September 8, 2017

RE: Initial Submission Review – Saddle Rock East Coffee Shop – GDP
Amdt, PDP Amdt and Site Plan Amdt
Application Number: DA-1216-20
Case Number: 1998-2007-04; 2003-7008-01; 2017-6034-00

STARBUCKS COFFEE COMPANY
LOT 4, BLOCK 1, SADDLE ROCK EAST COMMERCIAL SUBDIVISION FILING NO. 1
COUNTY OF ARAPAHOE, COLORADO
45,295 SQ. FT. (1.040 ACRES)
SITE PLAN

SHEET NUMBER:
1

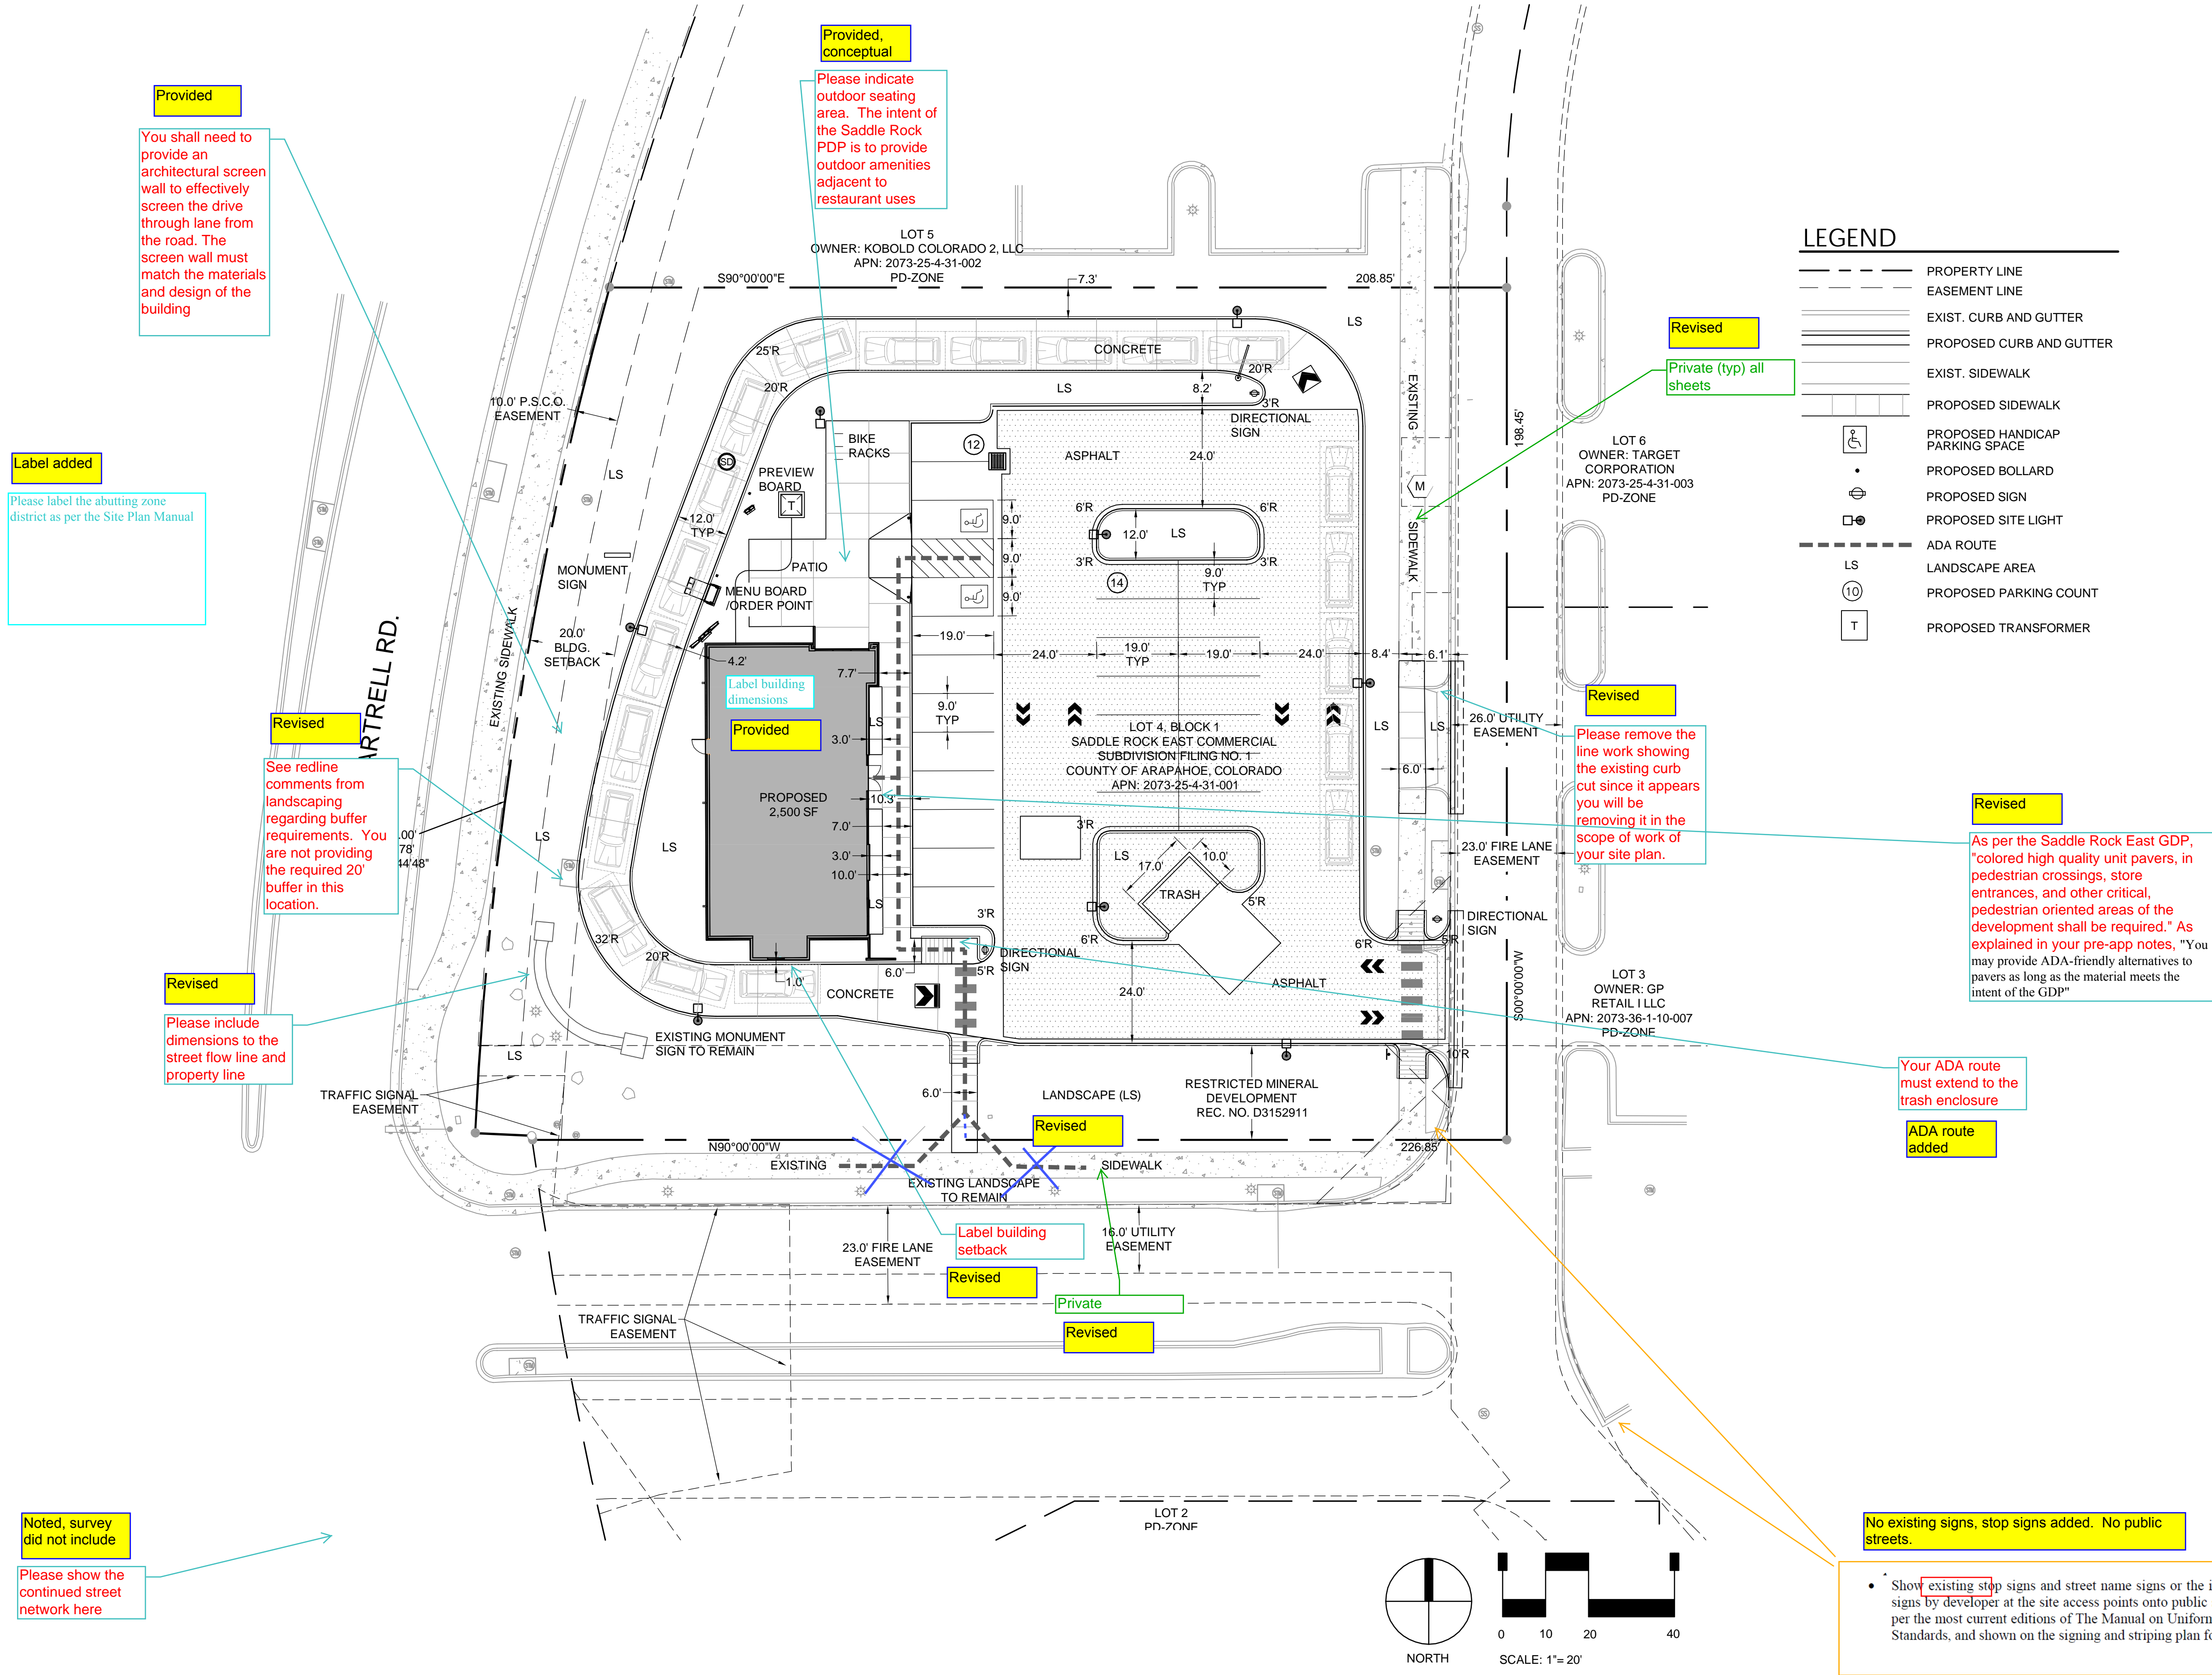
Please provide a vicinity map that is not an aerial. The vicinity map should label all major roads.

Please specify Saddle Rock East General Development Plan (GDP) Case Number 1998-2002

Provide 2015-IBC construction type and use group.

Please specify, you must also clarify the percentage of sign area which will be for the logo

Update phone number to 303-739-7447

Please include Bicycle parking required and proposed. Bicycle parking is required by Code Section 146-1508. Code requires non-residential development to provide bicycle parking at a minimum of three percent of the required motor vehicle parking spaces.

Revised

Note added

Revised

Revised

Revised

Revised

Revised

Provided

CURB RAMP DETAIL (PRIVATE) (B)
NOT TO SCALE

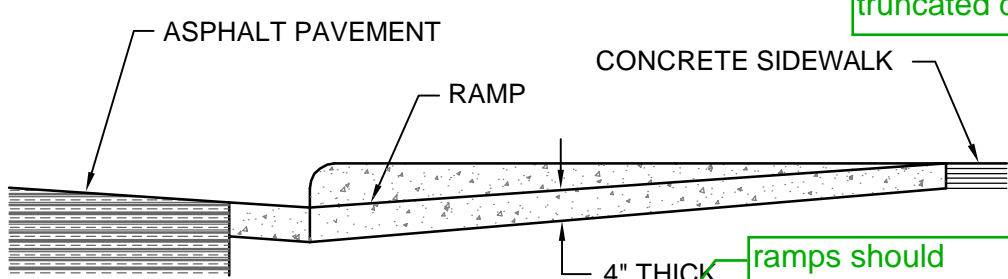
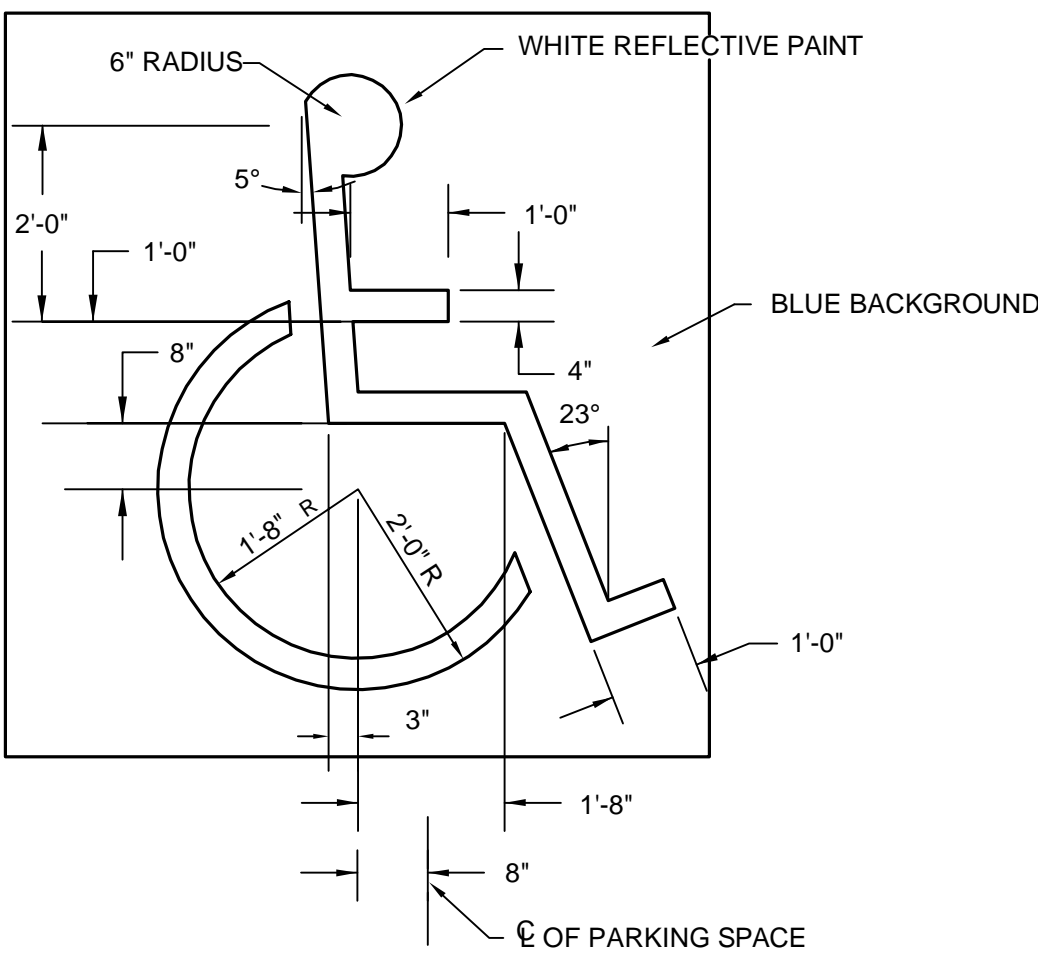
do not see this type of configuration on site plan

2% maximum slope over truncated domes

ramps should match sidewalk width which is 6'

Private

concrete should be per COA standards this does not need to be specified on site plan

SDA Response:
Correct curb ramp details have been added to correspond with the site plan.

SDA Response:
Are truncated domes required for private curb ramps?

SDA Response:
Minimum width has been changed to 6'.

SDA Response:
"Private" designation has been added.

SDA Response:
Concrete specified has been updated to meet COA standards.
